Kefauver Tract, Bradley Hills Preliminary Plan 120110100

Staff Report Date: 2/10/12

Description

Figure 1 Tree Save Area Located At Rear Of Subject Property

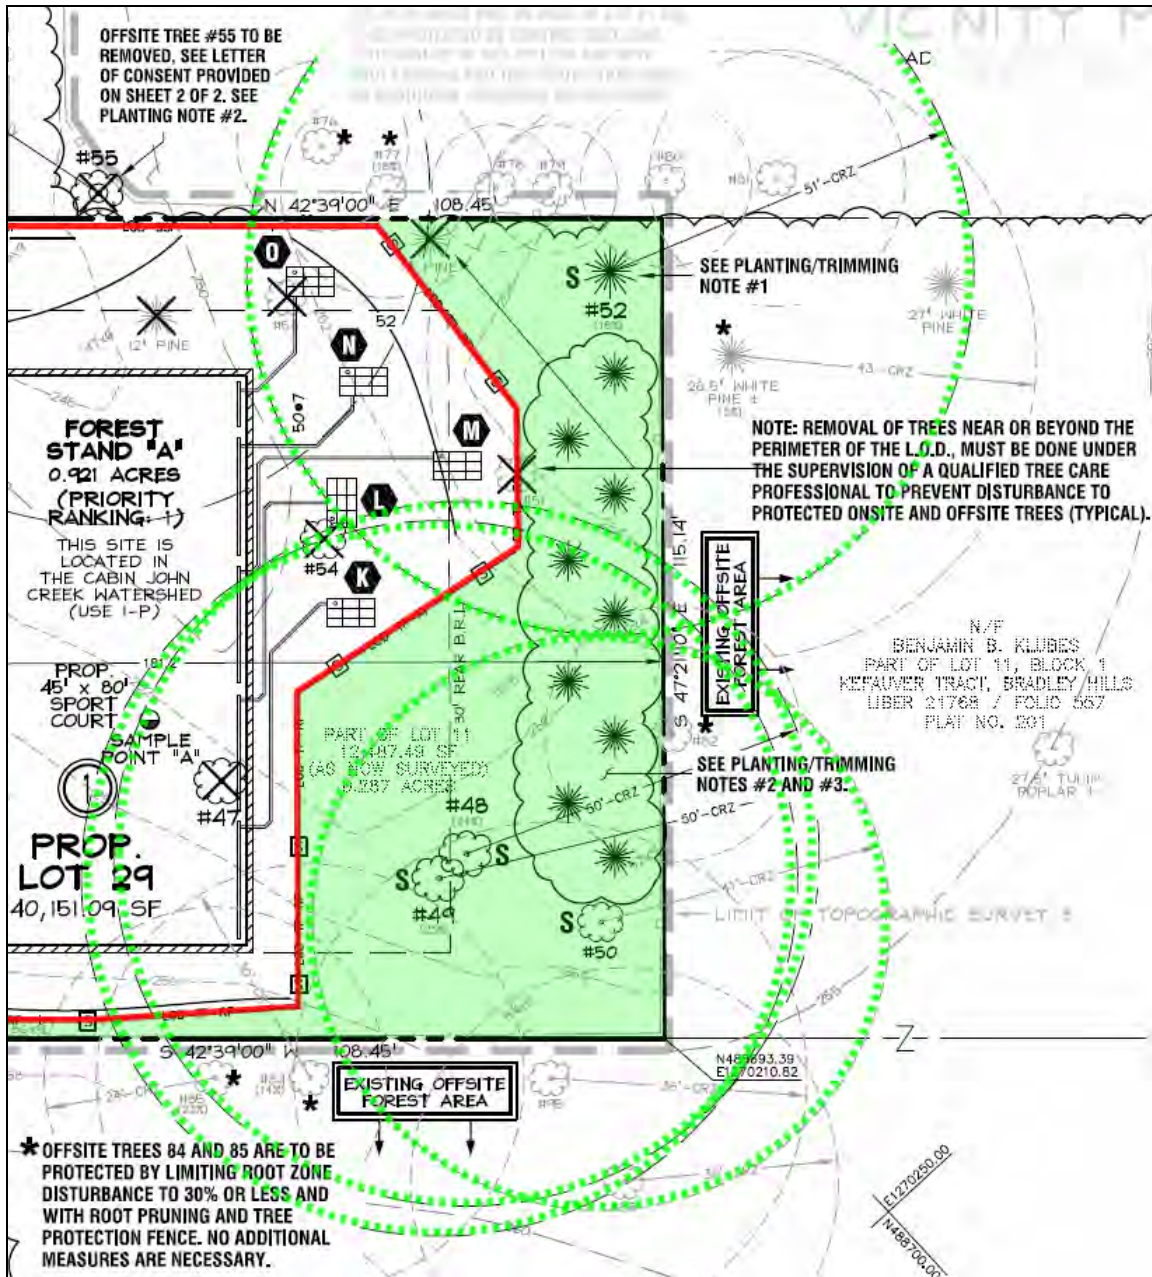
The proposed limit of disturbance (LOD) indicates that the majority of the site will be cleared. Four large trees at the rear of the property are preserved by the plan. The LOD near the retained onsite trees is located 20 to 50 feet from the property line (refer to Figure 1 below). The onsite tree save area is not proposed to be included within a forest conservation easement. However, the trees preserved in the area by the LOD and the variance, along with the supplemental plantings of native evergreens, will help maintain a buffer for the adjacent property. Since no forest conservation easement is proposed, the entire site is considered to be cleared.

Staff does not recommend a forest conservation easement for this property due to the lack of any overlapping environmentally sensitive features such as steep slopes, erodible soils, wetlands, streams, or associated buffers. The reforestation planting requirement of 0.57 acres is proposed to be met offsite by purchasing the equivalent credits at the Lorax Forest Conservation Bank. Ideally, the selection of an available forest conservation bank occurs within the same watershed as the subject property. Since no banks are available within the same watershed, the next preference is to select the geographically closest bank. The Lorax Forest bank is the only bank in the down-county area. It is located four miles from the site and currently has the necessary credits available.

Figure 2 Possible minor impacts to offsite trees on opposite side of Bradley Boulevard

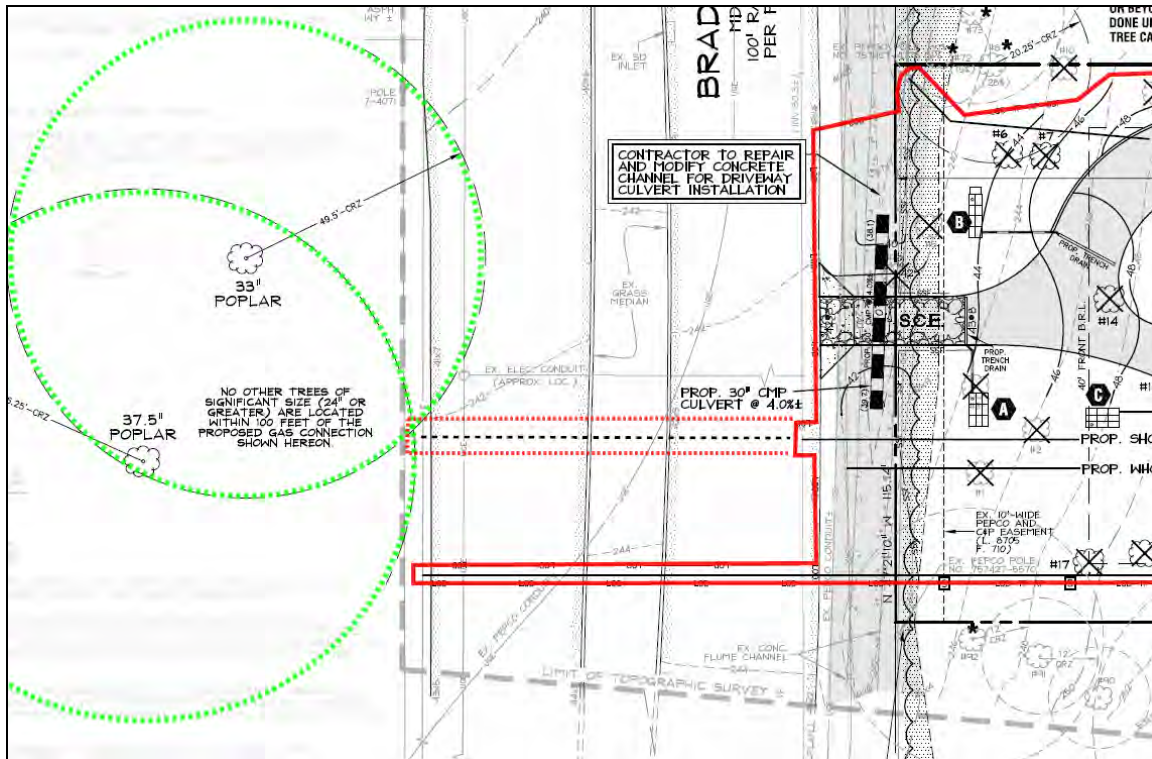
No disturbance is currently proposed to the two large tulip trees on the opposite side of Bradley Boulevard. The proposed gas house connection has been located as far as possible from the respective critical root zones of these two trees, but it is conceivable that Washington Gas may choose to install the line elsewhere, resulting in minimal disturbance of less than 1% of the critical root zone to either tree. No protective measures are being proposed for these two trees. The minor impact to these two specimen trees by possible construction activities is listed in the variance section below.
